AERONAUTICAL CHARTING FORUM
Instrument Procedures Group
April 23, 2013

FAA Control # 13-01-311

Subject: Terminal Area Arrivals

RNAV (GPS) RWY 3 CLEVELAND REGIONAL JETPORT (RZR)

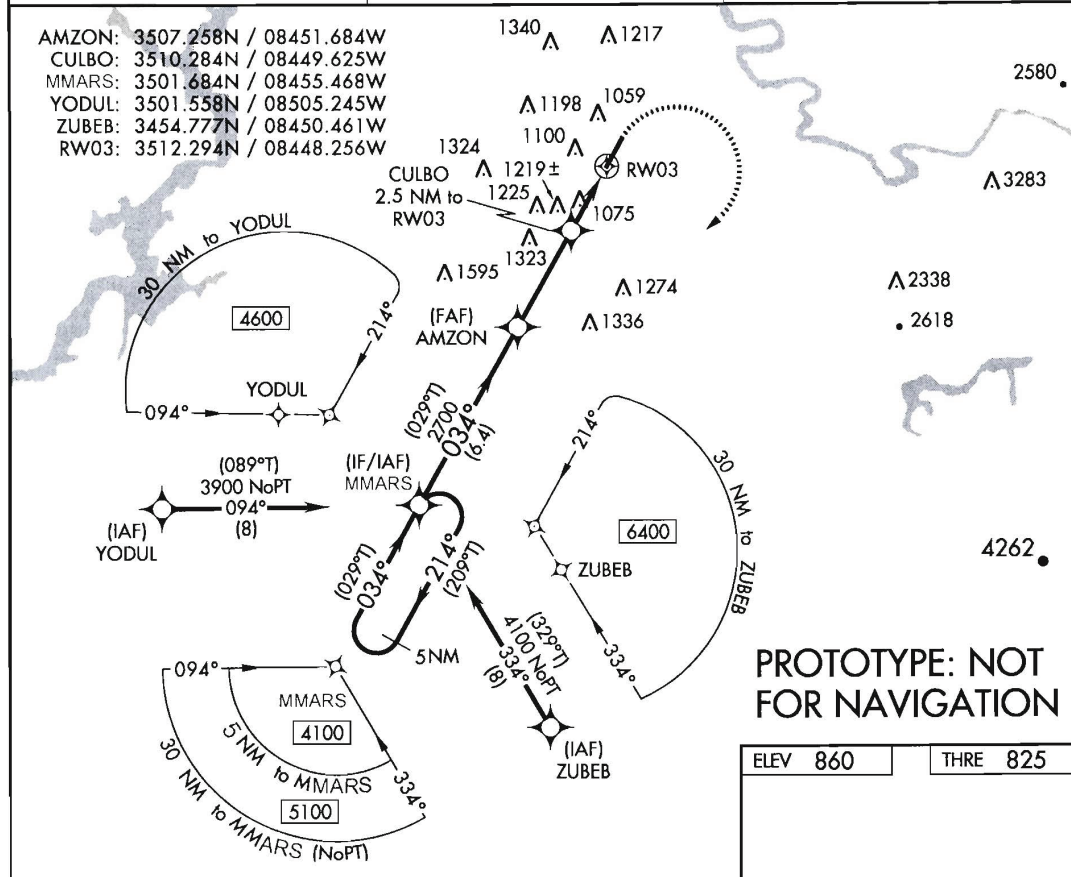
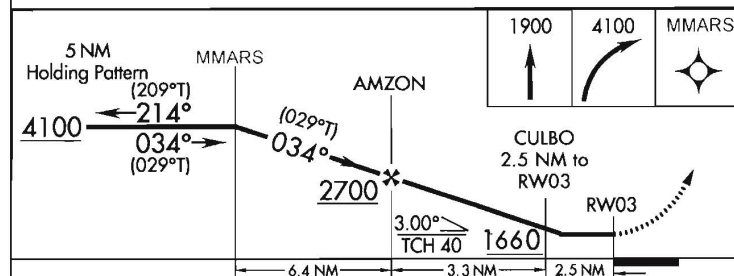
Added Comments: In support of this ACF-IPG Recommendation Document, NBAA conducted a test bed simulation of the Cleveland Regional Airport (KRZR) RNAV (GPS) RWY 3 approach that is posted on the FAA Coordination web site (see attached flight inspection graphic). This test simulator used manual entry of waypoint data and did not include a programmed vertical path. Key points resulting from this simulation are:

- Page 4 shows that the initial roll-up begins 5.9 miles from YODUL.
- Pages 9-10 show that even though the leg distance from YODUL to MMARS is 8 NM, the airplane does not achieve wings level until less than 2.5 NM from MMARS.
- There was no tailwind component throughout the simulation. Imagine the difficulty if the winds at 4000 MSL were say, 320/60.
